DIABLO CANYON POWER PLANT UNIT NO(S) 1 AND 2

**WELDED JOINTS CONCERNING WELD DESIGN, DRAWING DOCUMENTATION, INSTALLATION AND QC INSPECTION**

Date November 17, 1983  
File No. 929, CA-2  
Subject Welding on Two Parallel Sides  
of Structural Tube

### 1. FLARE BEVEL AND FLARE-V GROOVE WELDS DRAWING REPRESENTATION

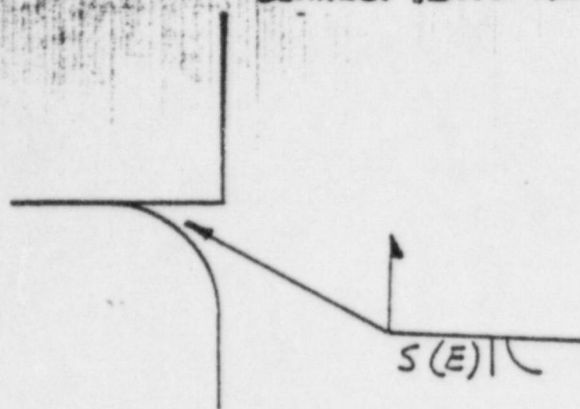
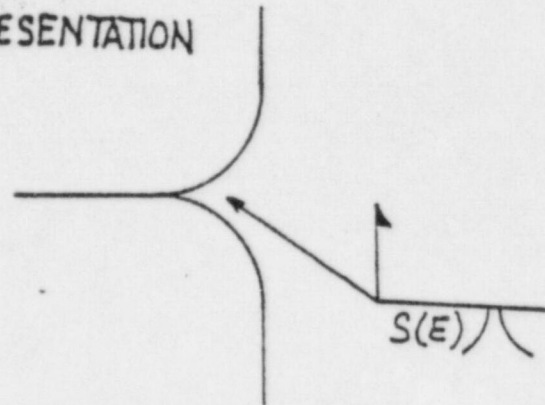
Bechtel San Francisco-No partial welds have been shown since S(E) have been omitted. AWS 2.1.3 and 2.10.3.1 and 2.10.3 state that (S) groove weld depth and (E) effective throat shall be specified on shop or working drawings. The hanger drawings sent to the field are both shop and working drawings. Also, M-9 states that only pre-qualified joints should be used on Diablo Canyon. Many in management contend that this job is not covered by AWS code. However, M-9 states that it is governed by AISC 7th, Ed.. In AISC section on welded joints, page 4-131, paragraph 4, AISC states that small deviations are possible per AWS code and other joint forms and welding procedures may be employed provided they are tested and qualified in accordance with AWS D1.1-72. Therefore, Diablo is governed by AWS D1.1-72.

Bechtel Site-One group has complied with call outs above. However, Pullman QC per ESD 223 have required the removal of S (E) from all drawings. This was because the ESD does not provide a procedure for them to use to verify the welds above. The symbols left, after removal of S (E) indicate full penetration welds even though, QC states this is not the case.

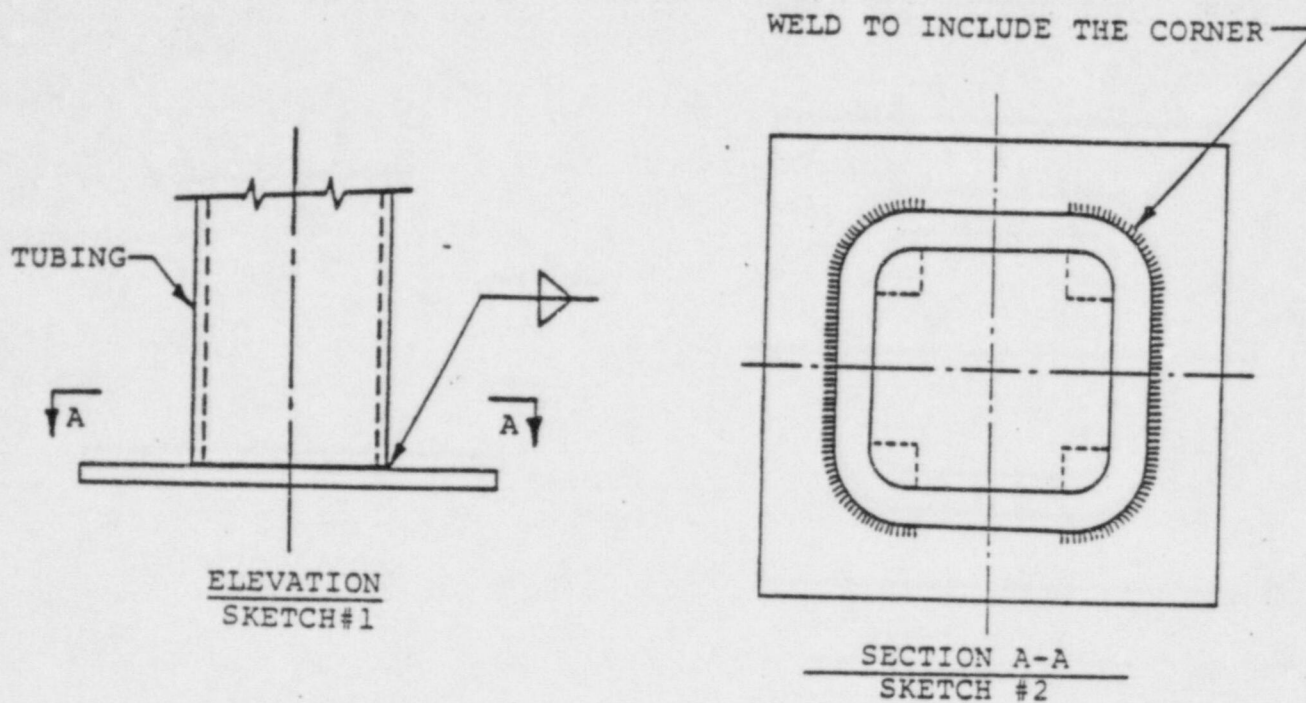
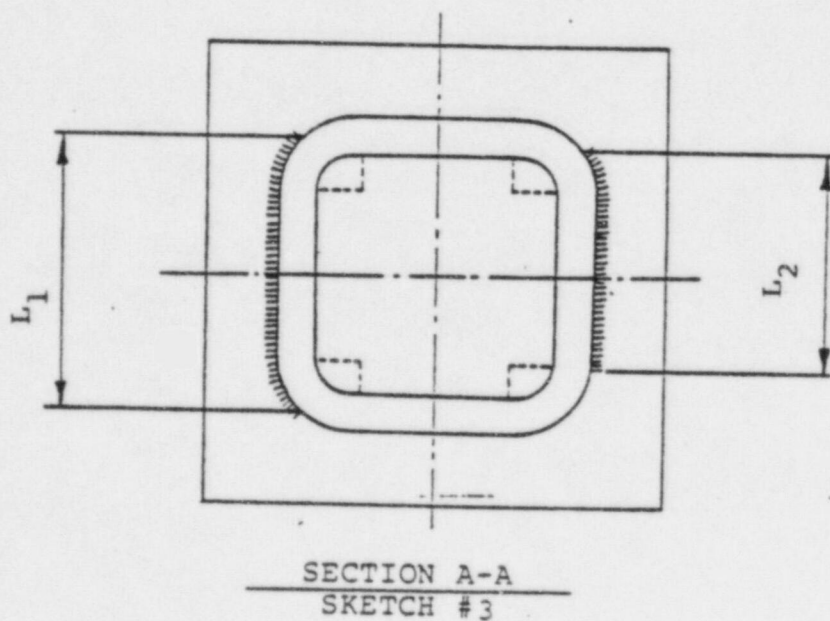
The weld symbol shown in Sketch No. 1 of the attachment has often been used with the welding of structural tubing. This weld should be interpreted to include the corners of the structural tubing as shown in the Sketch No. 2 of the attachment.

For pipe supports already constructed with such welds and for which as-built drawings have not yet been issued, please mark on the as-built drawings the actual weld lengths L<sub>1</sub> and L<sub>2</sub> as shown on Sketch No. 3 of the attachment.

FOR EXISTING WELDS, THE AS-BUILT SHALL  
SPECIFY THE ACTUAL WELD LENGTH  $L_1$  &  $L_2$
